Condition Description:

During NRC modification inspection, the SBO App R Diesel Generator test could not be used to independently verify the Post Mod Test Plan Requirements (PMTP). The documentation within the test was not adequate to demonstrate that the PMTP requirements.

CR-IP2-2008-02917 CA1
Operability Input
SBO / Appendix R DG Testing

Flow Chart

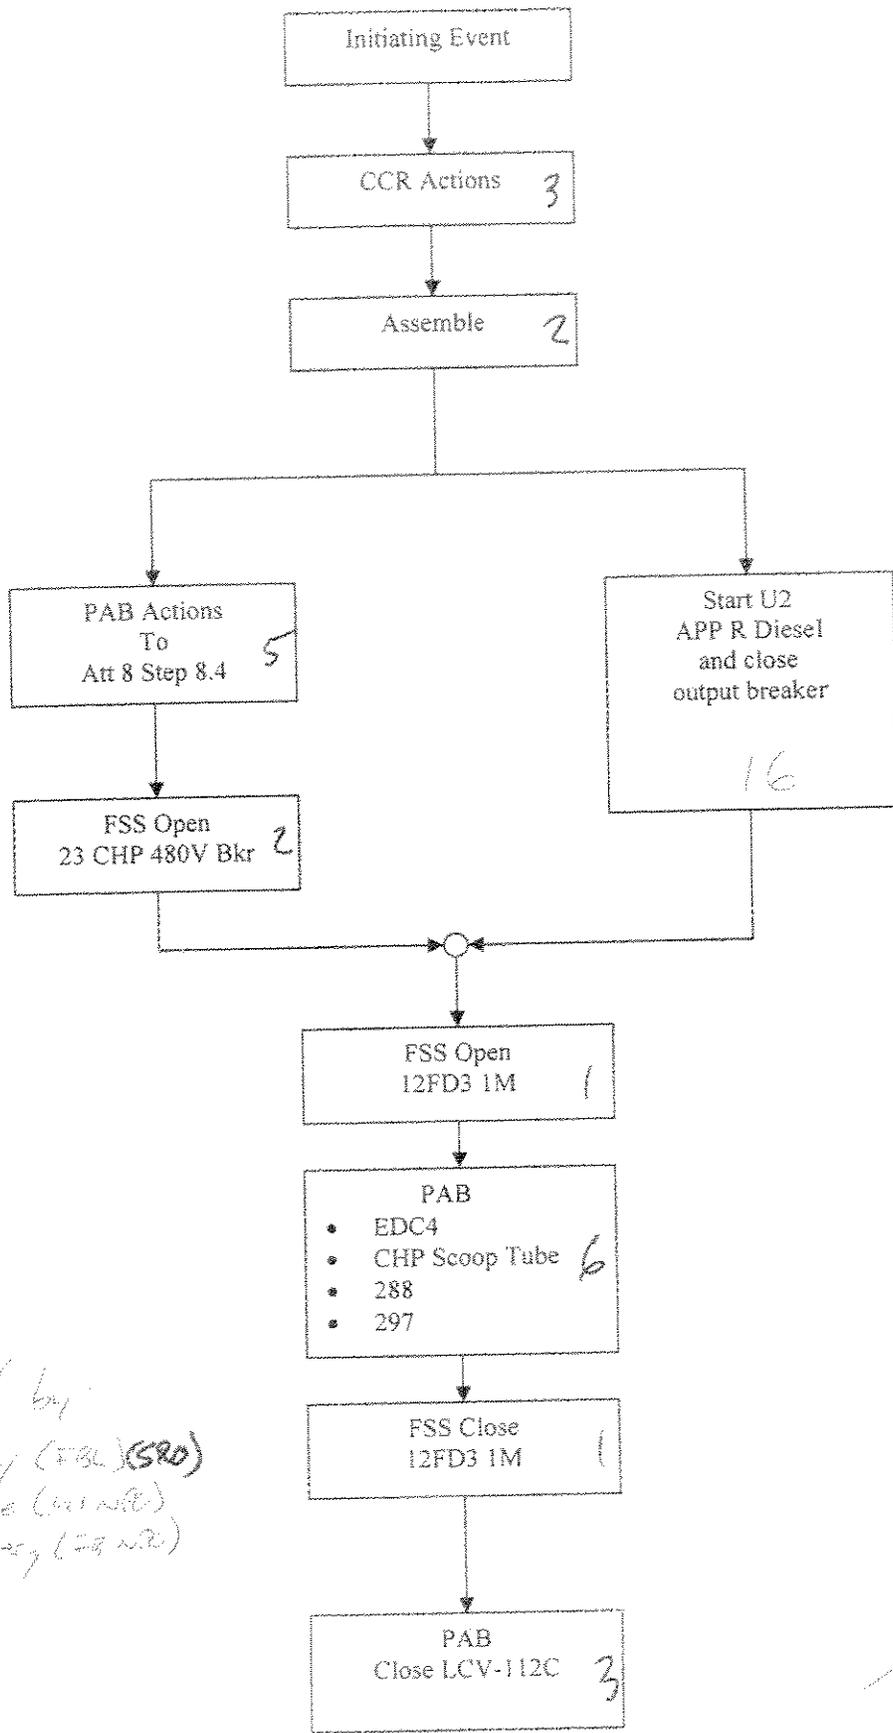
In addition to the first operability and CA1 justifications for functionality of this condition report we ran a simulated walk through of 2-AOP-SSD-1 from the initiating event through loading a charging pump onto the App R diesel. Total time to accomplish the task was 32 minutes which was well within the target of 60 minutes. This walk through was accomplished in segments and included transit time and parallel actions. See attached documents for flow chart and procedures used. Based on this walk through, the previous operability, and CA1, the App R diesel is considered FUNCTIONAL.

The simulation provides additional justification for functionality met.

U2 SBO

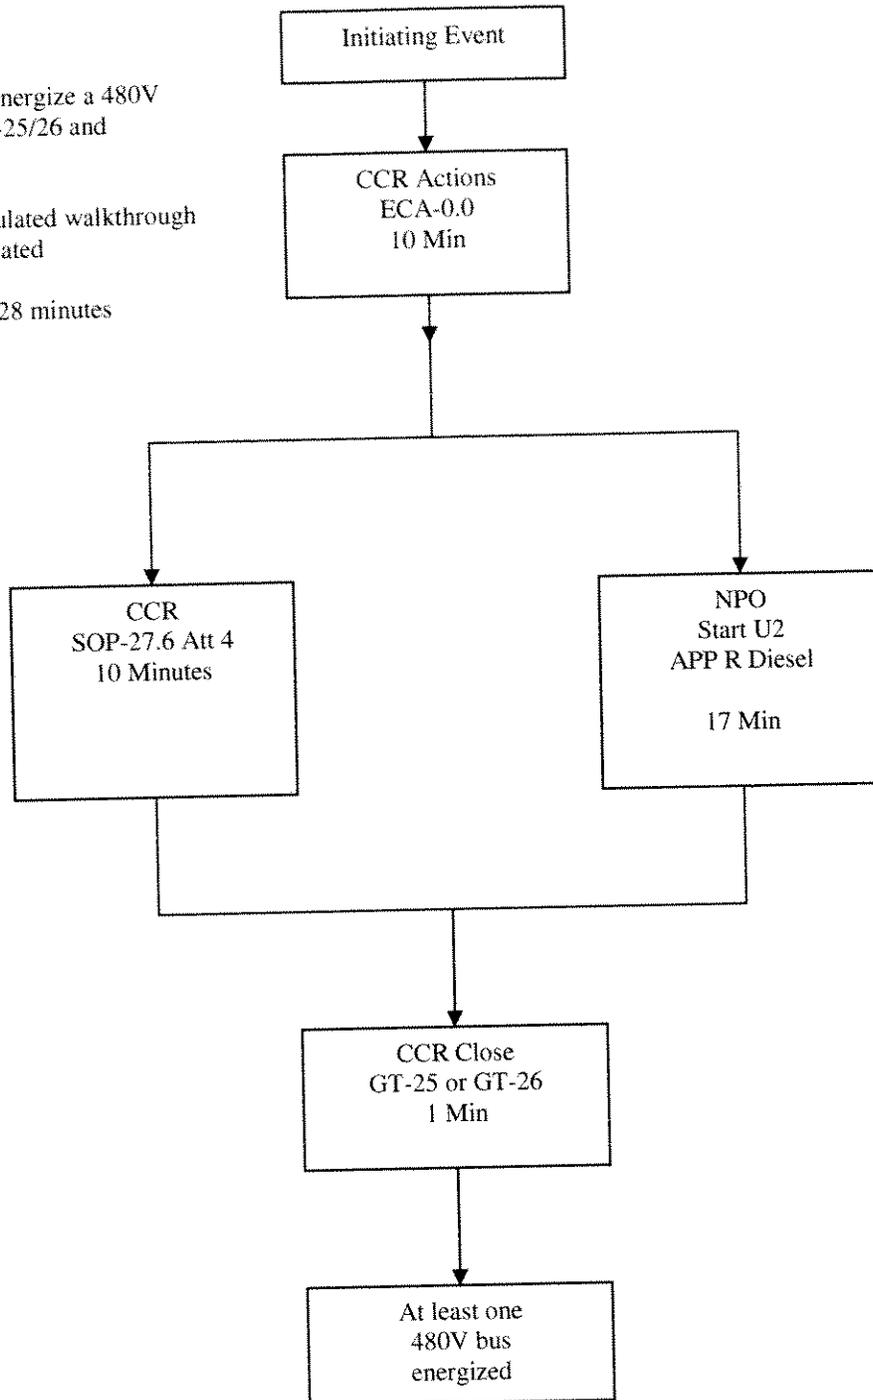
The Unit 2 SBO and Unit 3 SBO functions of the Unit 2 App R Diesel were performed in a timed simulation. Attached are the procedures and flow charts associated with these walk throughs. The Unit 2 SBO scenario was able to demonstrate a 28 minute interval from initiation of the event until 6.9 kv buses 5 and 6 were powered from the diesel. The unit 3 scenario is timed from notification from unit 3 that they require the unit 2 App R diesel until power is supplied to breaker GT/BT which was 24 minutes. Based on these timed walk throughs it is reasonably assured that the operators will be able to meet their committed times for supplying Unit 2 APP R diesel power to SBO loads with the current approved procedures as written. The Unit 2 App R Diesel remains functional.

SBO Event:
Time line to energize a 480V
Bus from GT-25/26 and
App R diesel.

Total time is 28 minutes

agree and approve
